Access Compliance Report

Public Rights-of-Way

(Pedestrian Signals)

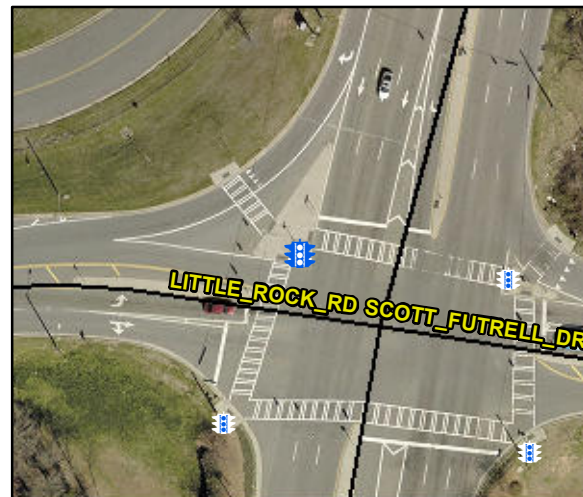
Compliance	Description	Data	Compliance	Description	Data
	Button Count	Button2	N/A	Distant to Additional Button (in)	N/A
	Additional Button Present?	No		Additional Button ID	N/A
N/A	Signal Buttons Required?	N/A	N/A	Additional Ped Posts Required	N/A
	How Many Ped Street Xings?	N/A		Located In An Island/Median?	N/A
N/A	B 1 Sign Present?	Yes	N/A	B 2 Sign Present?	Yes
Yes	B 1 Sign Purpose?	Yes	Yes	B 2 Sign Purpose?	Yes
Yes	B 1 Sign Lettering & Contrast?	Yes	Yes	B 2 Sign Lettering & Contrast?	Yes
Yes	B 1 Parallel To XWalk?	Yes	Yes	B 2 Parallel To XWalk?	Yes
Yes	B 1 PAR to Button?	Yes	Yes	B 2 PAR to Button?	Yes
Yes	B 1 PAR to XWalk?	Yes	Yes	B 2 PAR to XWalk?	Yes
Yes	B 1 Clear Floor Space?	Yes	Yes	B 2 Clear Floor Space?	Yes
N/A	B 1 FWD Approach?	No	N/A	B 2 FWD Approach?	No
N/A	B 1 FWD Approach Constrained?	N/A	N/A	B 2 FWD Approach Constrained?	N/A
N/A	B 1 FWD Approach Reach (in)	N/A	N/A	B 2 FWD Approach Reach (in)	N/A

N/A	B 1 FWD Approach Width (in)	N/A	N/A	B 2 FWD Approach Width (in)	N/A
N/A	B 1 FWD Approach Obstruction?	Yes	N/A	B 2 FWD Approach Obstruction?	Yes
N/A	B 1 FWD Approach Obstruction Dist (in)	3.0	N/A	B 2 FWD Approach ObstructionDist (in)	3.0
N/A	B 1 PARA Approach?	Yes	N/A	B 2 PARA Approach?	Yes
N/A	B 1 PARA Approach Constrained?	Yes	N/A	B 2 PARA Approach Constrained?	Yes
No	B 1 PARA Approach Reach (in)	20.0	No	B 2 PARA Approach Reach (in)	22.0
No	B 1 PARA Approach Width (in)	48.0	No	B 2 PARA Approach Width (in)	48.0
N/A	B 1 PARA Approach Obstruction?	Yes	N/A	B 2 PARA Approach Obstruction?	Yes
N/A	B 1 PARA Approach Obstruction Dist (in)	3.0	N/A	B 2 PARA Approach ObstructionDist (in)	3.0
Yes	B 1 Clear Floor Space Slope (%)	0.3	Yes	B 2 Clear Floor Space Slope (%)	0.4
Yes	B 1 Clear Floor Space XSlope (%)	0.9	Yes	B 2 Clear Floor Space XSlope (%)	1.2
N/A	B 1 PAR Slope (%)	N/A	N/A	B 2 PAR Slope (%)	N/A
Yes	B 1 Height (in)	46.0	Yes	B 2 Height (in)	43.0

N/A	B 1 Clear Xing Direction?	Yes	N/A	B 2 Clear Xing Direction?	Yes
	B 1 Crossing Direction	To S		B 2 Crossing Direction	To E
Yes	B 1 DistanceTo XWalk (in)	0.0	Yes	B 2 DistanceTo XWalk (in)	0.0
No	B 1 DistanceTo Curb (in)	98.0	Yes	B 2 DistanceTo Curb (in)	70.0
Yes	B 1 Diameter (in)	2.0	Yes	B 2 Diameter (in)	2.0

Possible Solutions: Replace Signal Push Button With APS Button on New Post. Remove & Relocate Sign. Remove and Replace Clear Space.
